PUBLIC WORKS
ENGINEERING SERVICES DIVISION
INTEROFFICE MEMORANDUM

SUBJECT: Final Addendum to the Initial Study/Mitigated Negative Declaration for the Bollinger Canyon Road/Iron Horse Trail and Crow Canyon Road/Iron Horse Trail Bicycle and Pedestrian Overcrossing Projects
(CIP 905530 and CIP 5531)

SUBJECT: Final Addendum to the Initial Study/Mitigated Negative Declaration for the San Ramon Iron Horse Trail Overcrossings Project (SCH# 2017082088)

San Ramon Iron Horse Trail Overcrossings Project
Site Plan

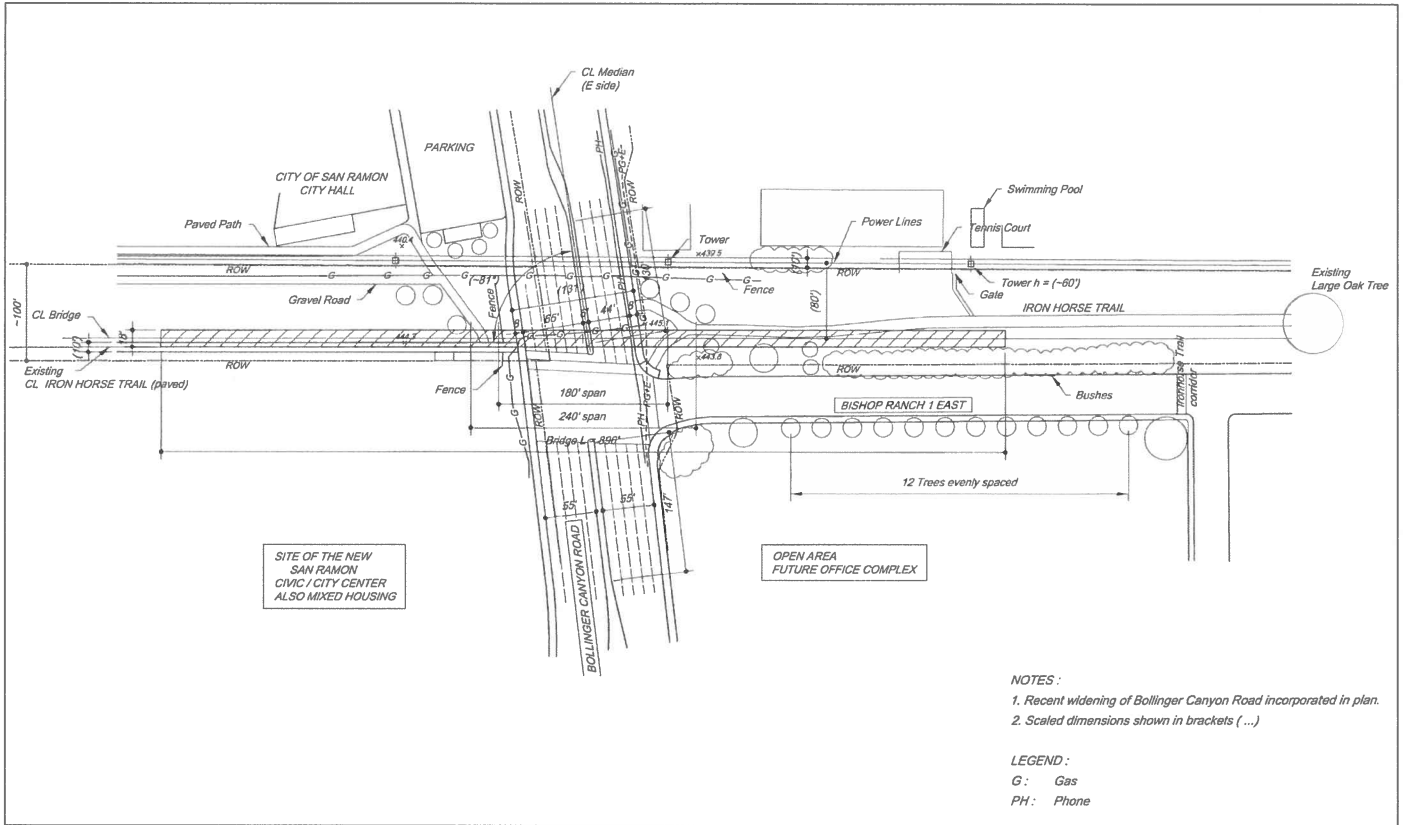
Since adoption of the Final IS/MND and approval of the proposed project on November 28, 2017, the City has refined the design for the Bollinger Canyon overcrossing to include a shorter cable stay bridge with a central support. The central support would require slight modifications to the overall bridge design and the elimination of the existing left turn lane on Bollinger Canyon Road. The description of the proposed Bollinger Canyon Road overcrossing as included in the Final IS/MND (pages 14 through 20) is shown below and revised as follows (revised text shown in underline and ~~strikeout~~). The proposed project, as modified, constitutes the “Revised Project.”

a. Configuration and Design. The Bollinger Canyon overcrossing would likely consist of a cable-stayed main span with a single central support tower located on the south side of Bollinger Canyon Road or a design of similar appearance. ~~Two options are considered for the preliminary conceptual tower design: a single mast (Figure 9) or an A frame (Figure 10).~~ From the northern to southern landings, the total length of the new overcrossing would be ~~between~~ approximately 950 933 linear feet to ensure ADA compliance. The width of the span would range between approximately 16 and 20 feet.

San Ramon Iron Horse Trail Overcrossings Project
 General Plan/Elevation

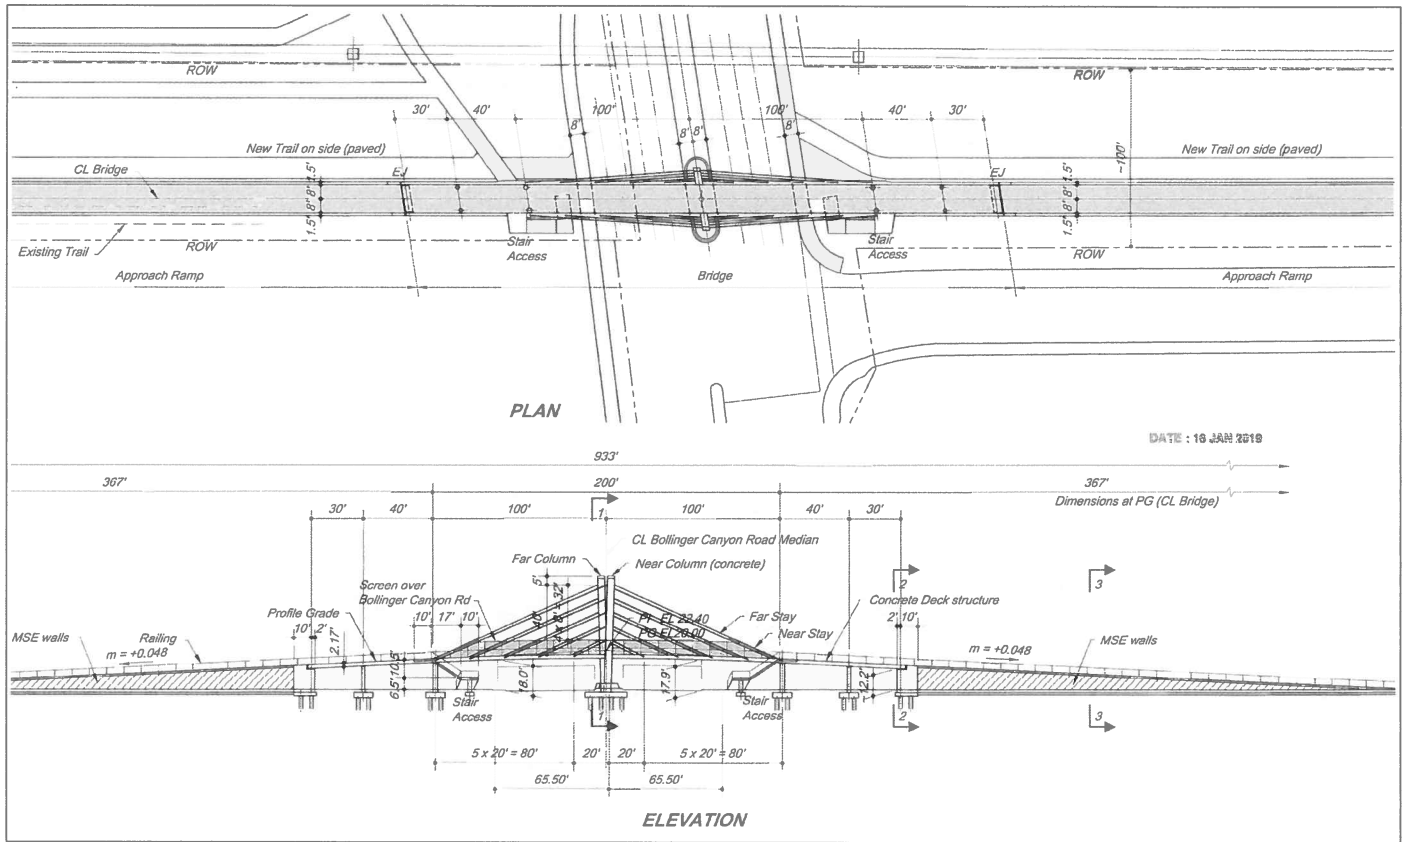
Based on the preliminary conceptual bridge designs, the northern approach would consist of Mechanically Stabilized Earth (MSE) retaining walls and an aerial approach structure supported by columns. The retaining wall would be up to 20 feet high at the aerial structure abutment. The aerial approach structure would be either a concrete girder or a steel girder structure. Following the widening at Bollinger Canyon Road, the proposed cable-stayed span would cross over the existing future 114-foot-wide roadway (curb to curb) and a ~~back span~~ would be connected to the southern approach. The southern approach would consist of MSE retaining walls that would be up to approximately 20 feet high at the cable-stayed bridge abutment. All approaches would have a continuous slope of less than 5 percent in accordance with ADA standards.

Back span cColumn supports could be made of concrete and would range from 3 to 6 feet in diameter at the base and between 10 and 19 feet tall. The columns could be supported by pile groups or drilled shafts. The top of pile caps or drilled shafts would be at least 2 feet below ground. The minimum vertical clearance of the bridge superstructure would be approximately 17 feet and the height would be approximately 24 feet from the existing grade. The tower component would be a maximum of approximately ~~135~~ 70 feet tall. Depending on the width of the overcrossing determined through the final design, the path could consist of shared or separated bike and pedestrian/~~equestrian~~ travel lanes. Guardrails would be located on the length of the pathway and would be a minimum height of 4 feet tall. Lighting may also be installed along the length of the overcrossing; specific lighting standards and maintenance requirements would be developed as part of the final design phase.
